Proposed Carrington West Wing Open Pit Mine Extension
Hunter Valley Coal Measures

**Review of the Mackie
Environmental Research Modeling Report**

Dr F R P Kalf
B Sc, M. App.Sc, PhD
Kalf and Associates Pty Ltd
Hydrogeological and Numerical Modeling Specialists

22 December 2010

Figure 1. Key hydrogeological features of the Carrington mining site
(Base map taken from EA 2010 Appendix C - Fig 1)

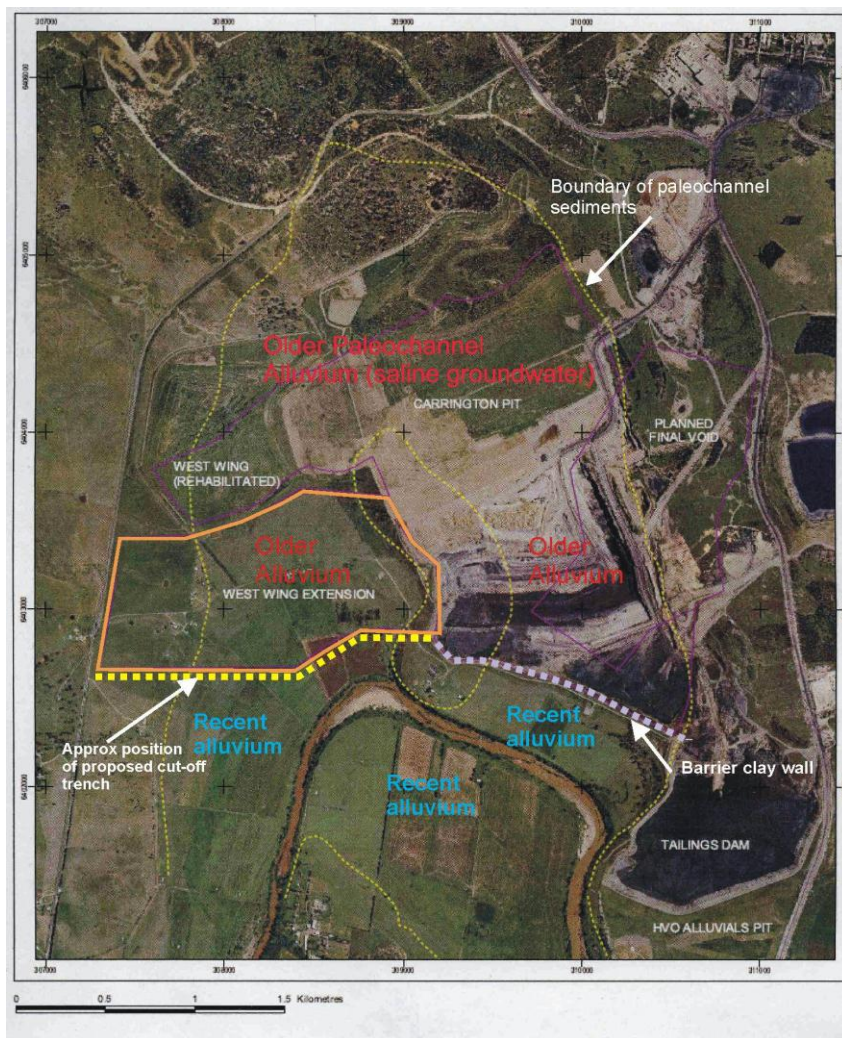
Figure 1 shows the key hydrogeological elements of the site area interpreted from the EA report, and discussions with Dr Mackie. They include the paleochannel¹ (older) alluvial zone, its outer and inner boundaries; the more recent alluvial flats adjacent to the Hunter River; the existing barrier clay wall² across the eastern “arm” of the paleochannel and a proposed bentonite based slurry-trench cutoff³ across the western “arm” of the paleochannel. Existing mining includes the Carrington pit and the rehabilitated West Wing mining zone situated immediately north of the proposed West Wing Extension mining zone.

Because of the close proximity of the Hunter River to the existing mining zone (Figure 1) a clay barrier wall was constructed early in 2010 across the eastern arm of the paleochannel to impede any long term surface water leakage from the Hunter River through the adjacent river alluvium (and presumably weathered bedrock) into the existing Carrington mine pit.

It is proposed that a similar barrier, likely to comprise a bentonite based cutoff trench, would be constructed across the western arm of the paleochannel keyed into the underlying hard rock strata. This trench is also designed to impede leakage from the river to the proposed WWE pit during mining and recovery of the watertable.

Figure 2 showing the likely extent of more recent alluvium within the proposed WWE mining zone.

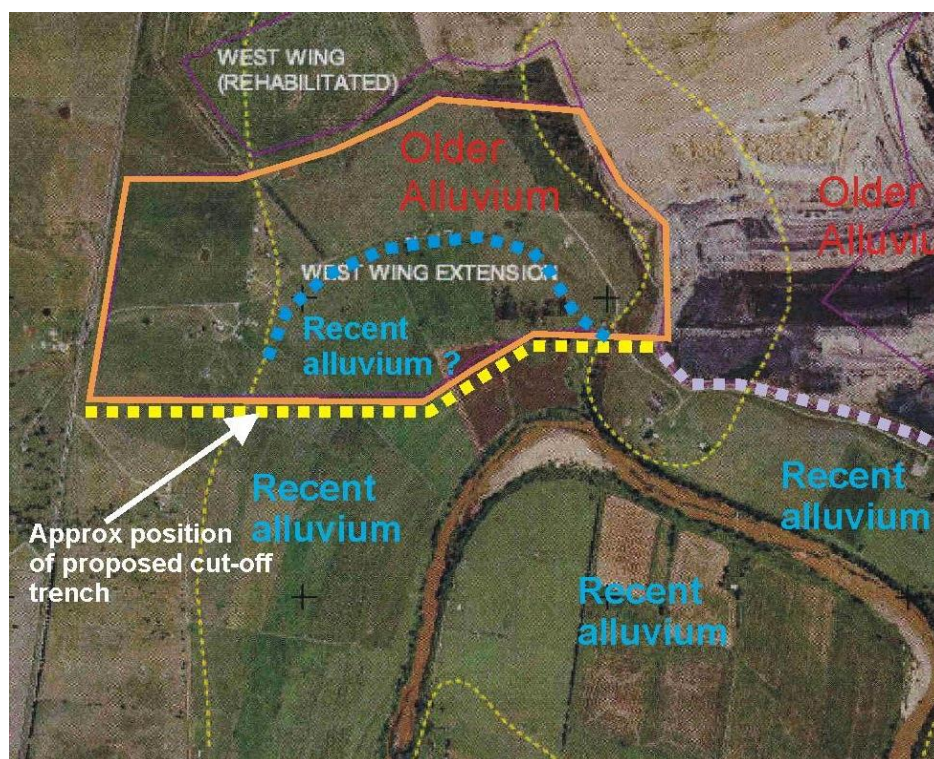
One aspect of the alluvial geology that is not completely clear is where the more recent alluvium ends and the older alluvium begins, within the western arm of the paleochannel. Based purely on photo interpretation it would appear that the boundary is situated as shown in blue in Figure 2. That is, about one third of the proposed WWE area is likely to be occupied by what could be classed as more recent alluvium.

As indicated in Figure 2 there will be some removal of the more recent alluvium but this would not constitute “destruction” of the alluvial aquifer. A large body of recent alluvium would remain after mining that would allow continuity of groundwater flow.
